Design Review Committee
August 11, 2011

SUBJECT: Case 17136, Substantive Site Plan Approval – Central Library

A new Central Library is proposed at the corner of Spring Garden Road and Queen Street. The project is subject to substantial site plan approval by the Development Officer and the Design Review Committee. The Design Review Committee is specifically charged with:

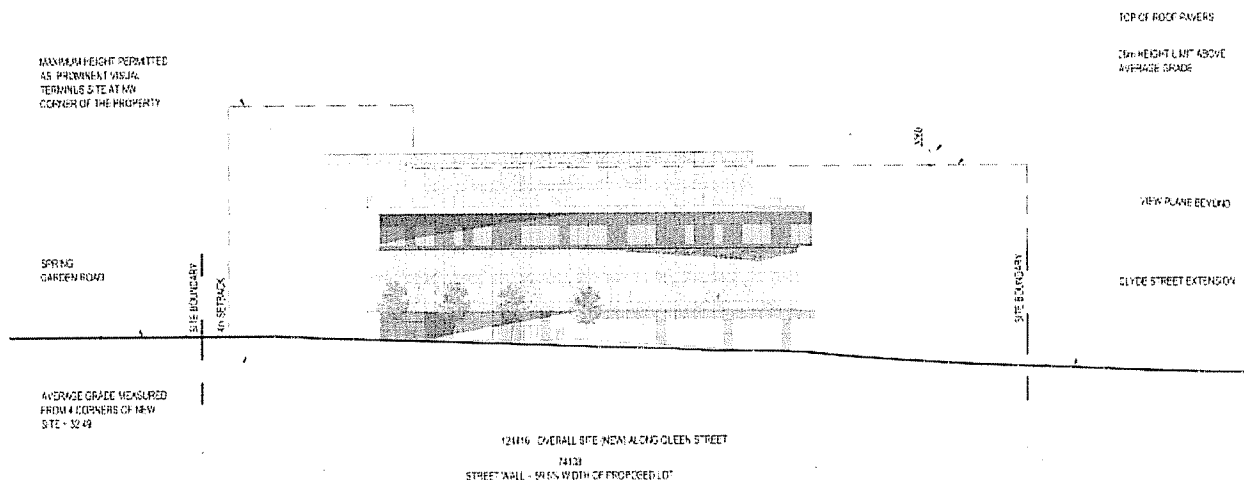
The building height is defined in plan or elevation and is measured from the average grade of the property, specifically the average of the four corners of the property. Because of the size of the library site and the general slope toward the south and east, the average grade is lower than if the site were limited to the footprint of the actual building only. Due to the desire to provide more public open space to the south and the sloping nature of the site, the design exceeds the 28 meter height limit.

It is worth noting that this additional height is allowing all the building's mechanical equipment to be enclosed rather than being placed on the roof and does not result in any additional floor area for the library.

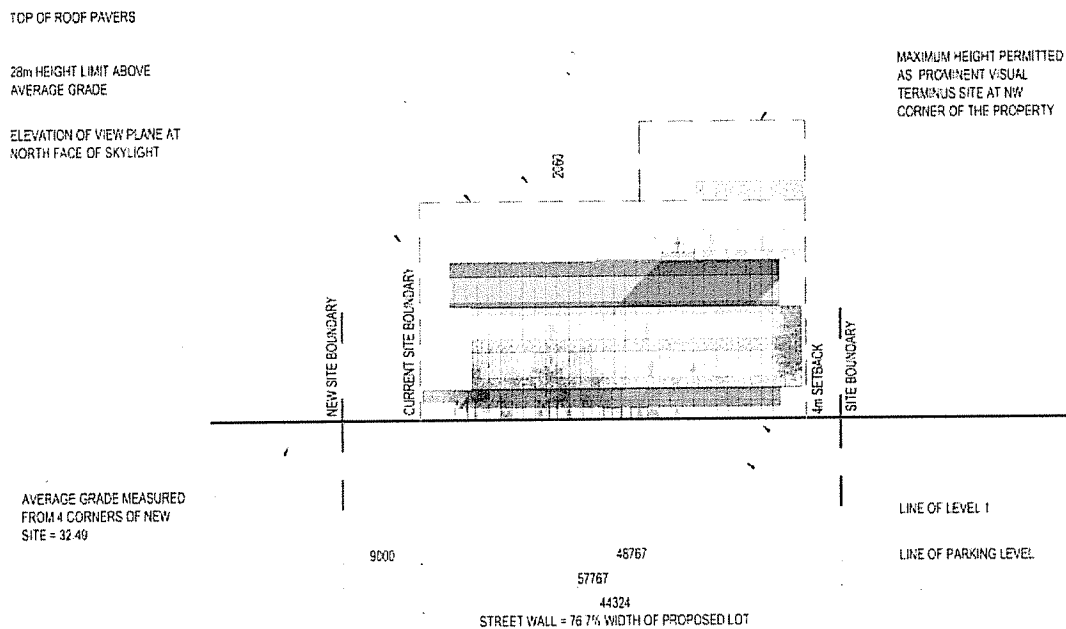
Due to the deep setback from Spring Garden Road to create a public plaza continuous with the space in front of Faculty of Architecture and Planning building, and the desire to create an open public plaza to the south, the new library's West elevation of 124m provides a streetwall width of 59.5% and as such will require a variance. Similarly, the steel wall width of the north elevation along Spring Garden Road is 76.7% and will require a variance.

Vertical Plane Projection Variance

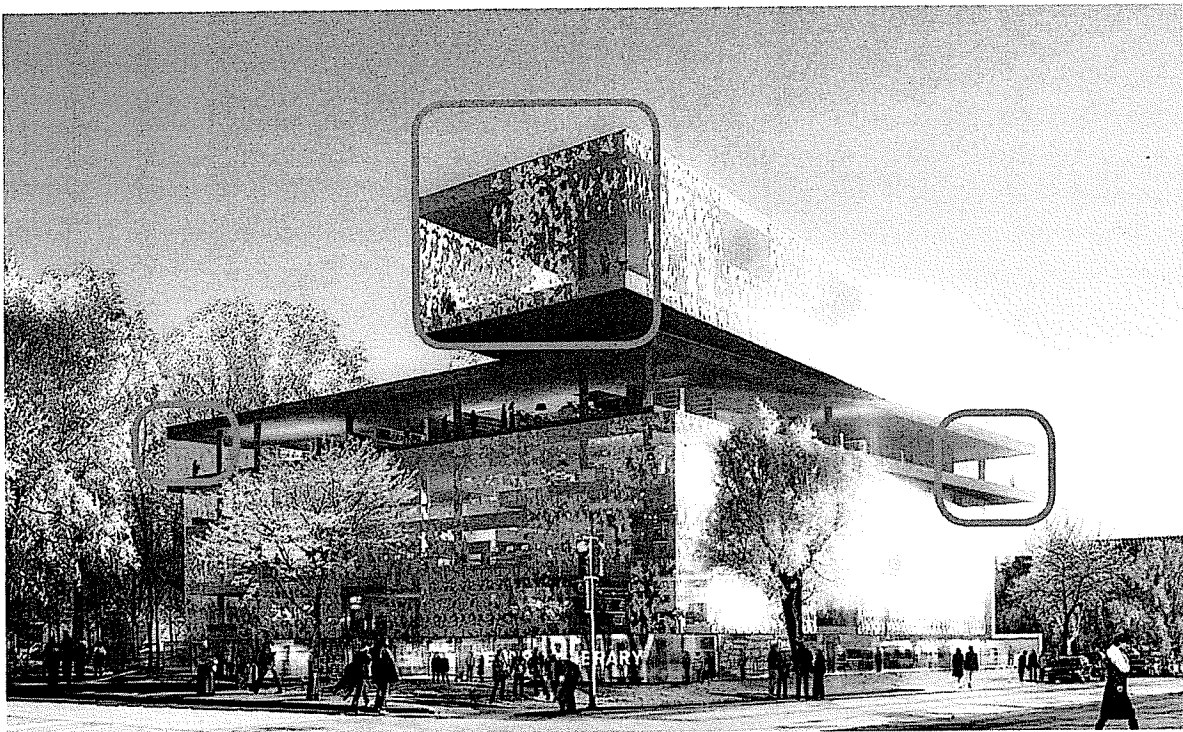
These features, unique to this project, do not meet the requirements of Section 10, Subsection (5) which states, "The mid-rise portion of a building shall not project beyond the vertical plane of the exterior walls of the low-rise portion of the building." A variance is required for these landmark features that are unique to the library.
